BICYCLING IMPROVEMENT OPPORTUNITIES

City of Fort Collins

Bicycle Advisory Committee

April 25, 2022

Prospect & Welch to Spring Creek

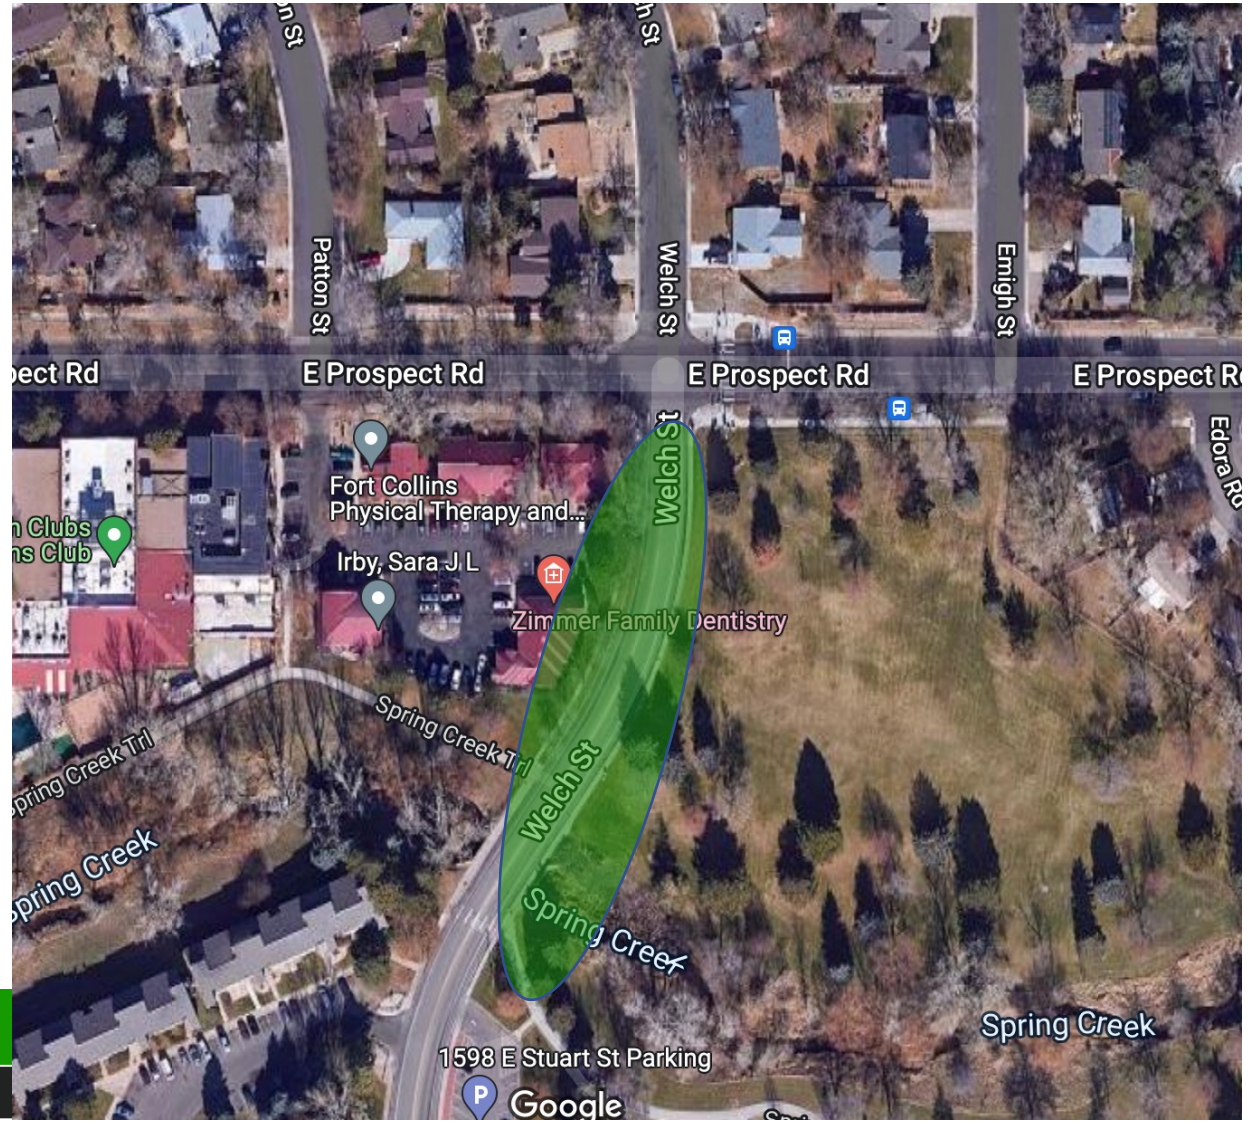
- Opportunity:
  - Signalized pedestrian crossing is on the east side of the Prospect & Welch intersection…
  - …making utilization of southbound (SB) bike lane on Welch (coming from the north) difficult, requiring a Dutch crossing or dangerous diagonal crossing at Prospect.
  - Improve the desired bike and pedestrian behavior between Prospect and the Spring Creek Trail on Welch St.

- Considerations:
  - Create a 2-way cyclepath on the east side of Welch between Prospect and the Spring Creek Trail

Stuart Street & Lemay Avenue

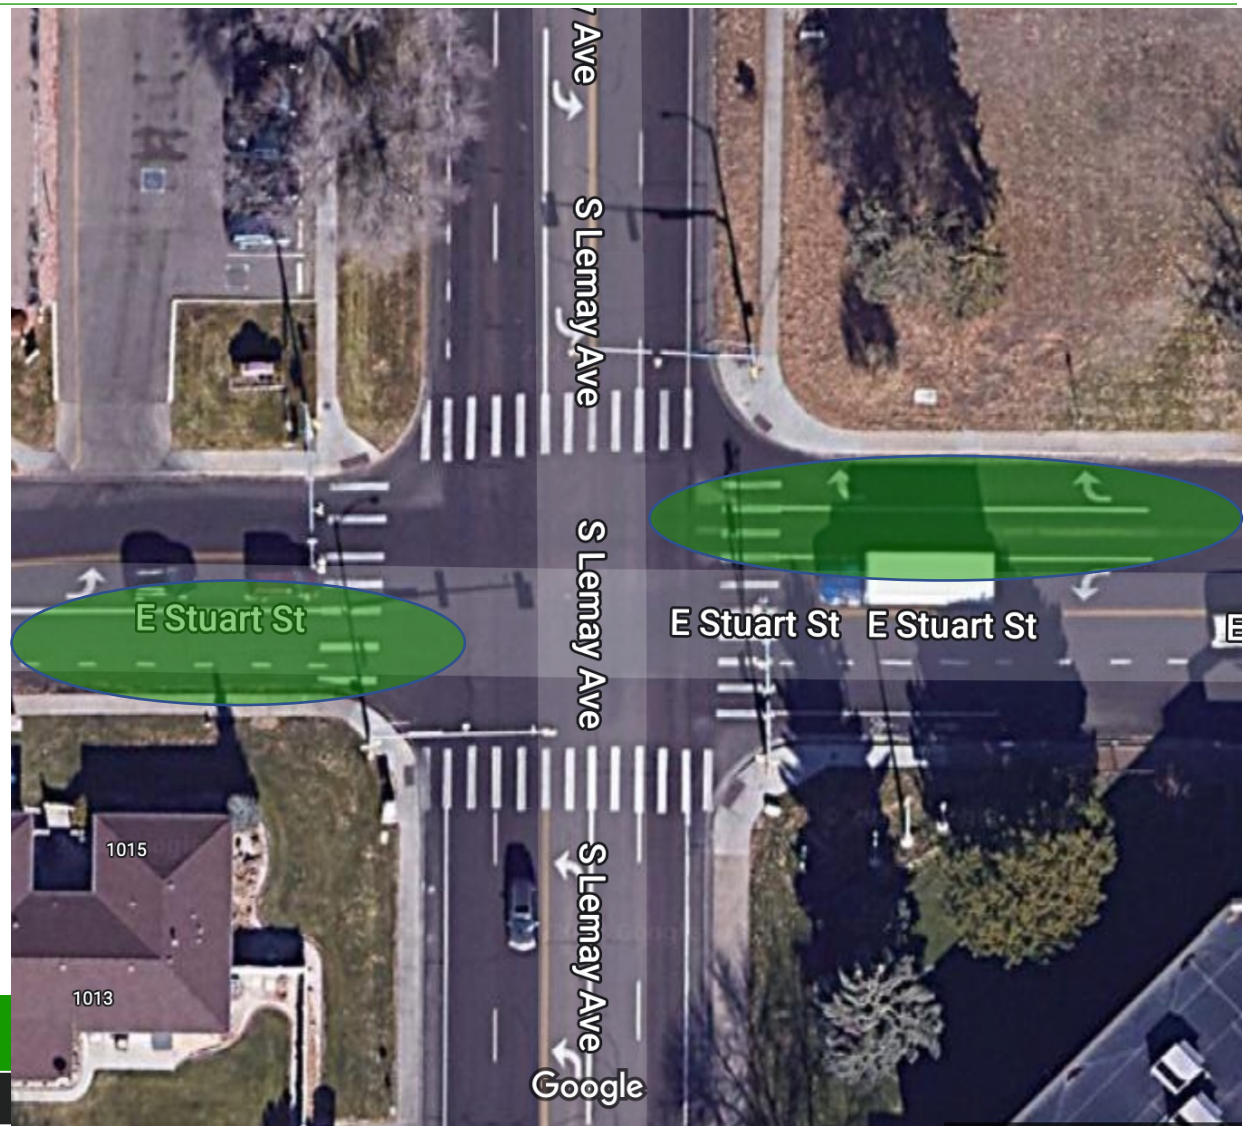
- Opportunity:
  - Both, westbound and eastbound directions on Stuart Street at the intersection of Lemay Avenue lack safe bicycle facilities

Stuart Street & Lemay Avenue

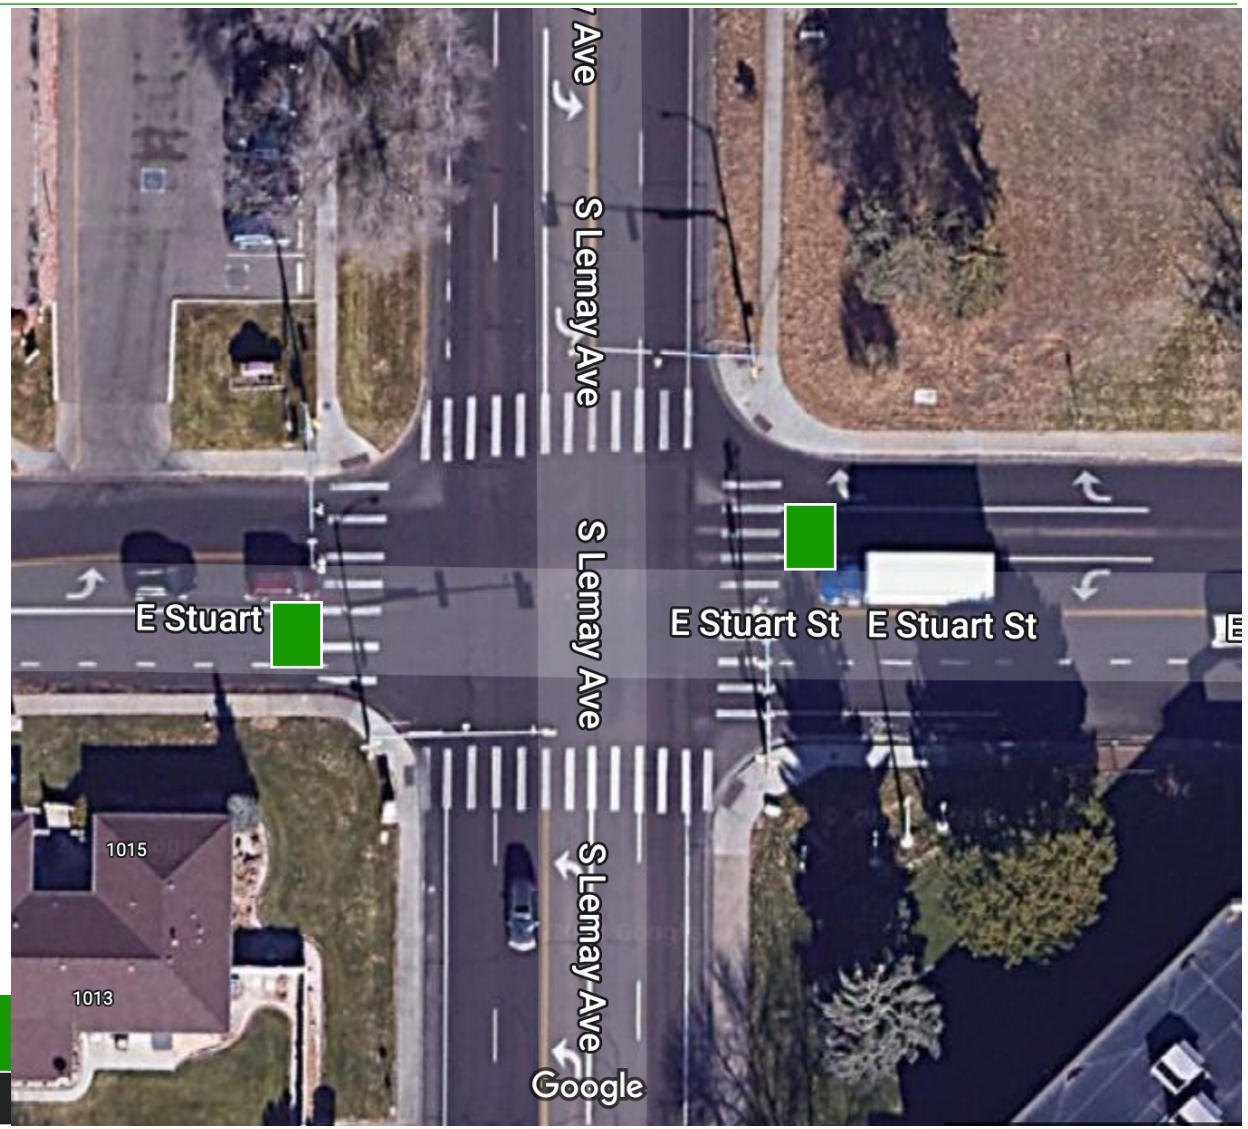
- Considerations:
  - Find a way to widen Stewart at the intersection allowing for adequate dedicated bike facilities in both directions.
  - Add bike boxes to the westbound and eastbound thru-lanes

(similar to those at Laurel & College, or Shields & Plum, etc.)

Prospect Road & Stover Street

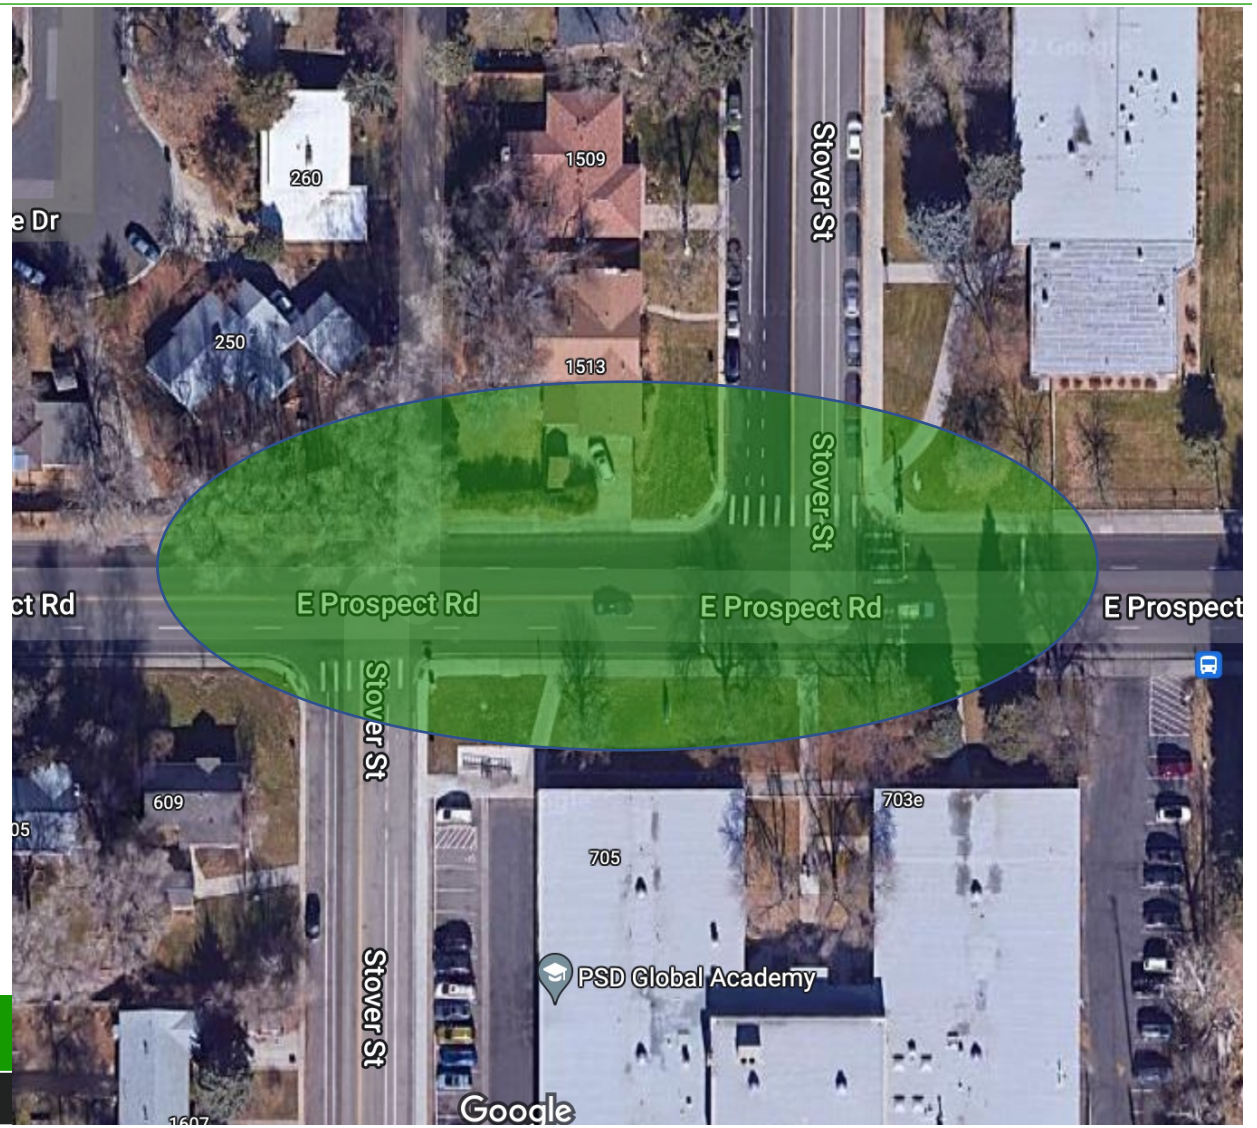
- Opportunity:
  - Stover crosses Prospect in an offset manner
  - Signalized pedestrian crossing is on the east side of the Prospect & eastern Stover intersection…
  - …making southbound (SB) cycling utilization difficult and potentially dangerous.
  - Improve the signal(s) at the crossing for bike and pedestrian safety.

- Considerations:
  - Add a bike/pedestrian crossing and signal that stops traffic west of the western Stover intersection (see *blue boxed area*).
  - Thus, when the signal stops east and westbound Prospect traffic, the intersection is open (*cross-hatched area*) from the eastern edge to the western edge.
  - Improve delineation between NB Stover bike lanes and travel/turn lanes.
